Technical Bulletin

Model: Paper Feed Unit PB3210/PB3220	Date: 04-Dec-13	No.: RD787001c
--------------------------------------	-----------------	----------------

Subject: Firmware	Release Note: Paper Feed L	Prepared by: E. Hinata		
From: 1st Tech Se				
Classification:	Troubleshooting	Action required		
	Mechanical	Mechanical Electrical		
	Paper path	Retrofit information		
	Product Safety	🛛 Other (Firmware)	🖂 Tier 2

Model: Paper Feed Unit PB3210 Da			Da	te: 23-Jan	: 23-Jan-15 No.: RD787002		
Subject: The pap while there is still p		Prepare	d by: E.Hi	inata			
From: 1st Tech Service Sect., MFP/P Tech Service Dept.							
Classification:	 Troubleshooting Mechanical Paper path Product Safety 	 Part info Electrica Transmi Other (al		Servic	required e manual revision it information

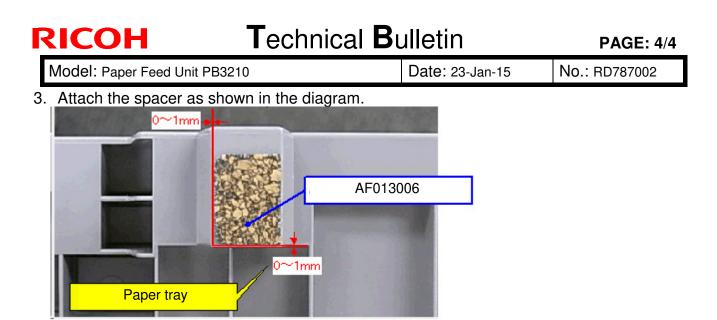
If the symptom occurs, attach the following spacer to the main machine paper trays 1, 2 and optional paper trays 3, 4.

1. Cut the pad into four equal sections as shown below (width: 12mm).

2. Clean the area of the paper tray that contacts the push switch with alcohol.

4. Press the pad firmly with your finger to ensure there is no peeling or lifting.

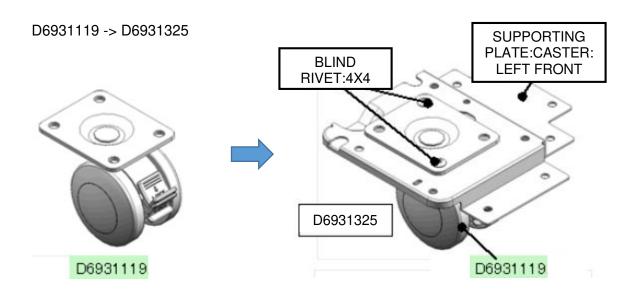
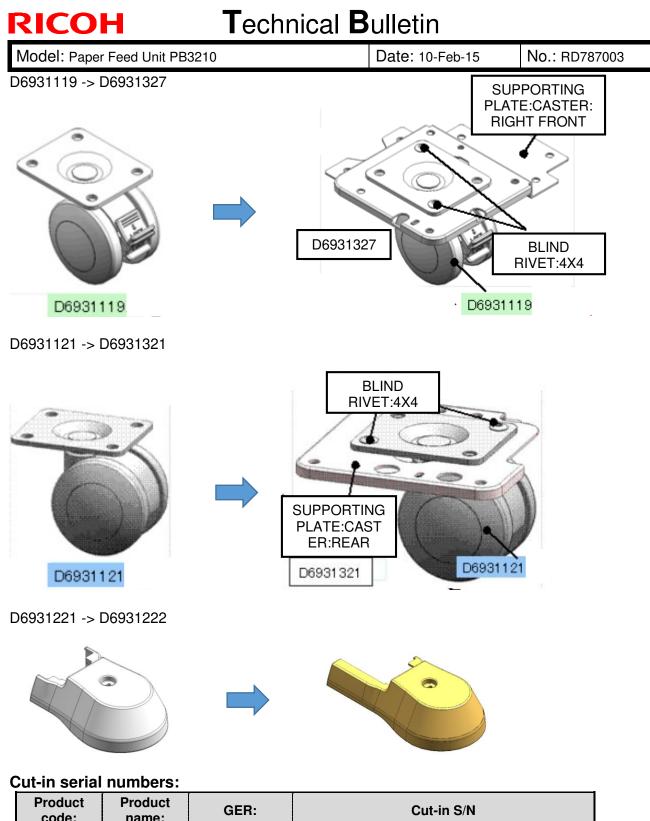
Change:

- 1. The caster and plate were registered together as an assembly.
- 2. The shape of the arm cover was changed.

- 1. To improve the part's strength against shock vibration.
- 2. To make the part easier to replace in the field.
